August 11, 2017

Re: ITI Comments on ENERGY STAR Version 7.0 Computers Draft 1 Specification

Figure 1

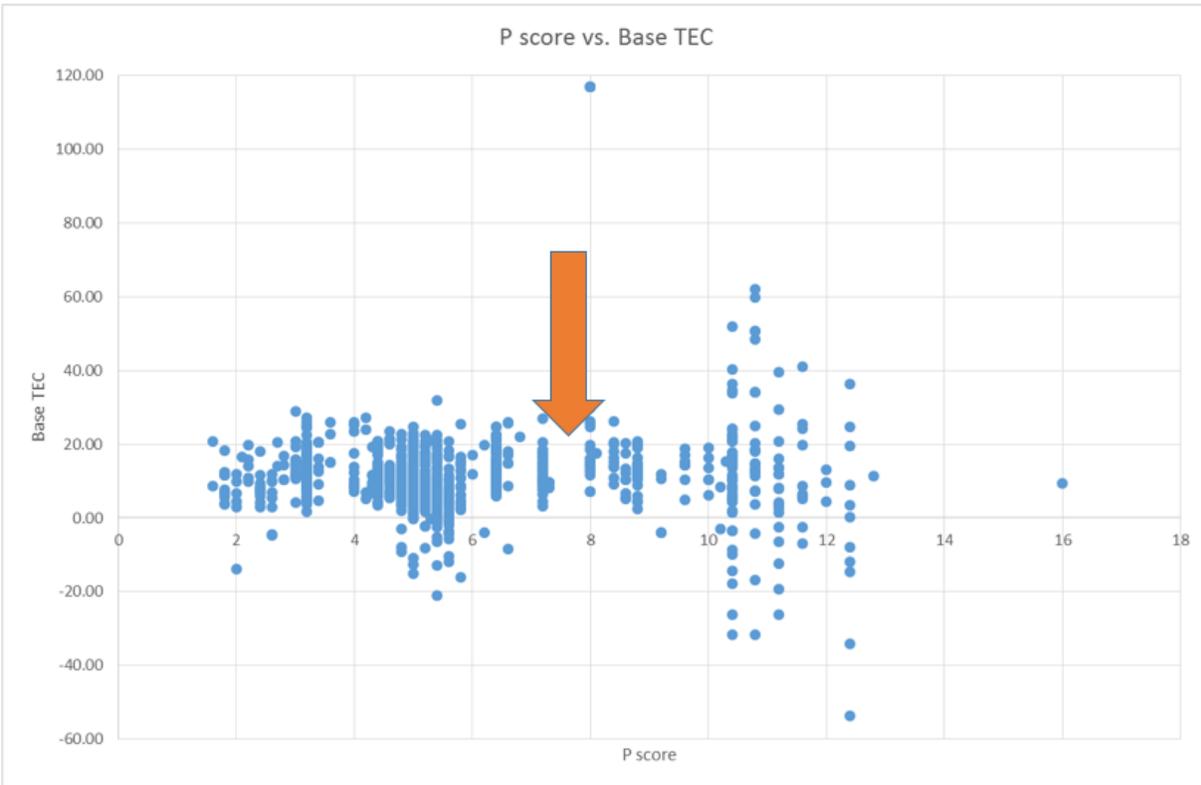
1. **Categorization:** The scatter plot in Figure 1(P-score vs. Base TEC) reveals the following issues:
 - P-Score vs. Base TEC does not show a good correlation. This was pointed out by ITI in its earlier comments to EPA.
 - While category cut-off point is difficult to assess, the biggest gap between NB1 and NB2 occurs between P Score values of 7.3-8.0, This is shown with the orange arrow in Figure 1.
 - ITI recommends the following P-Score (P) values for the proposed 3 categories.
 - i. NB0: $P \leq 2$
 - ii. NB1: $2 < P < 8$
 - iii. NB2: $P \geq 8$
